ADDENDUM #1 – FEBRUARY 26, 2025

RE: CITY OF PORT ORFORD
American Legion Building Remodel
Project #18.27.3

FROM: HGE ARCHITECTS, Inc.
333 South 4th Street
Coos Bay, Oregon 97420
541-269-1166

M6.0

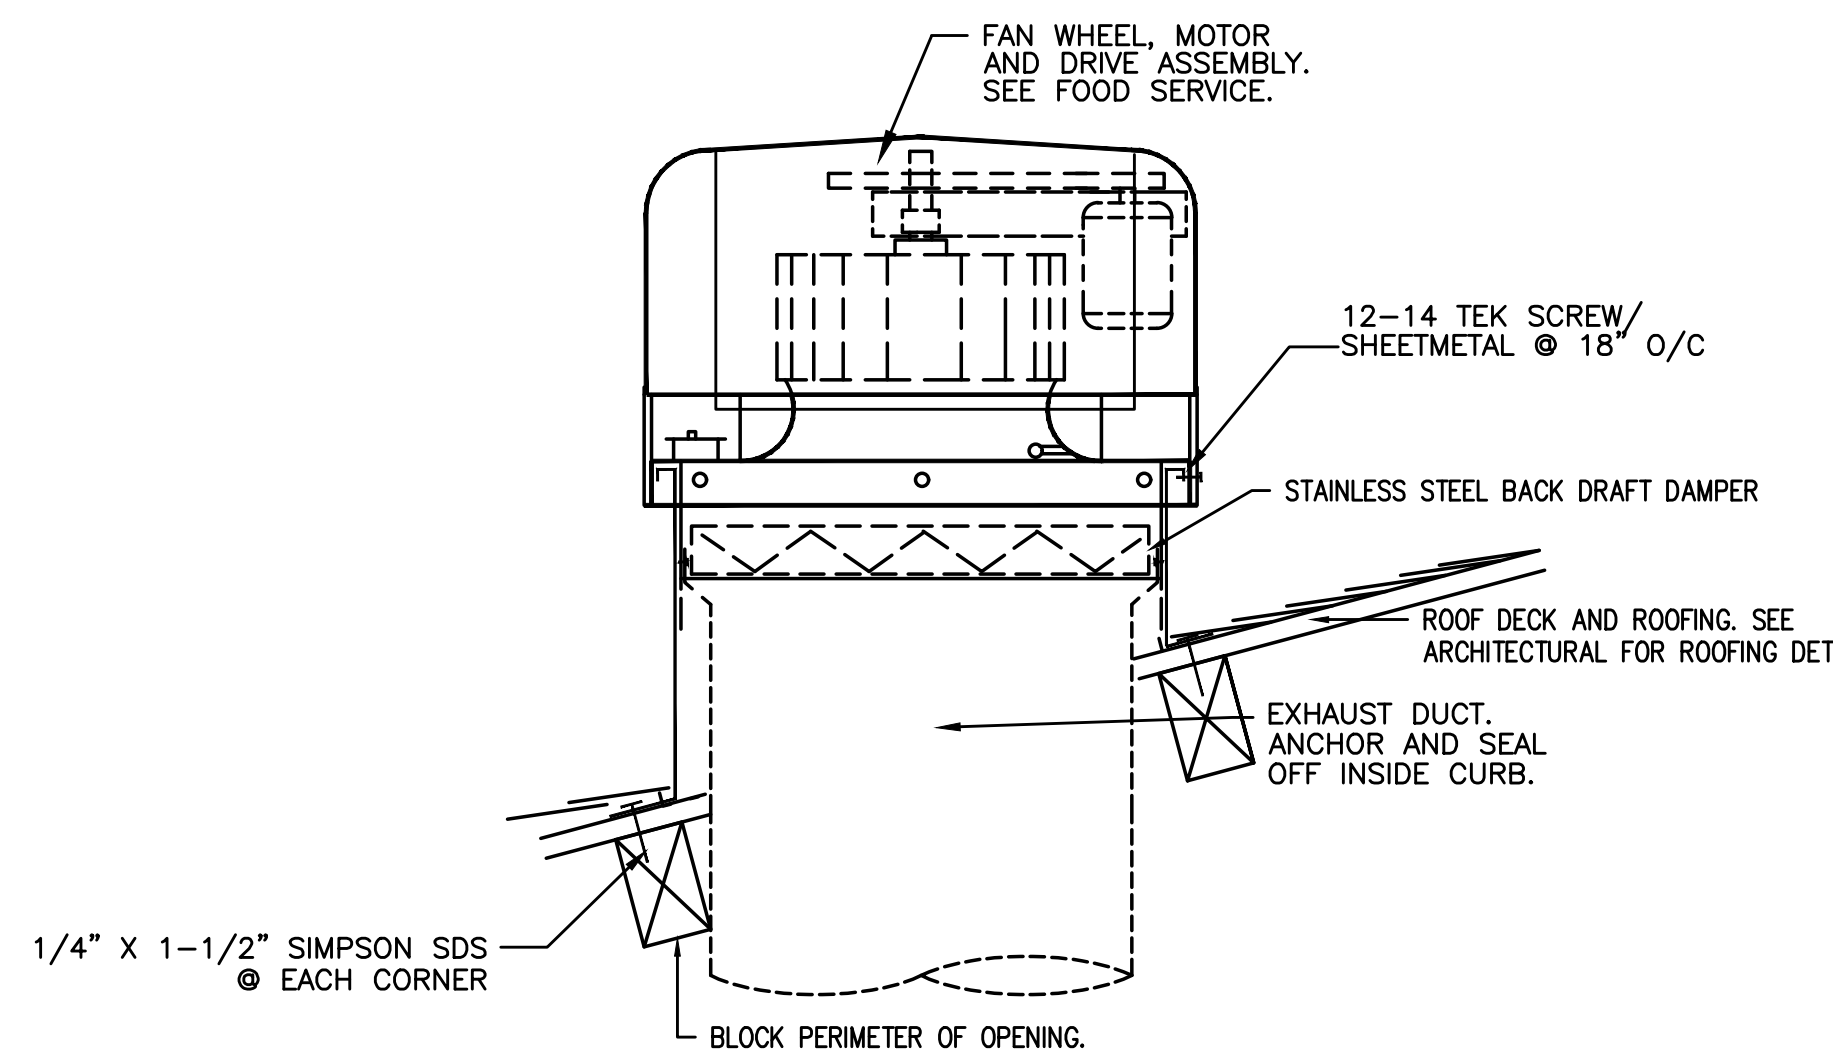
- 8. **Sheet M6.0 Mechanical Schedules and Details:** REPLACE with the attached revised Sheet in its entirety.
- 9. **Sheet E2.0 Electrical Plans Power & Lighting:** In Mechanical Equipment Schedule, ADD: "EF-1; Exhaust Fan; Kitchen: 100 W; 120 V; Ph 1; Notes 1, 3." Connect to circuit AL-37. See Mechanical plans for general location.
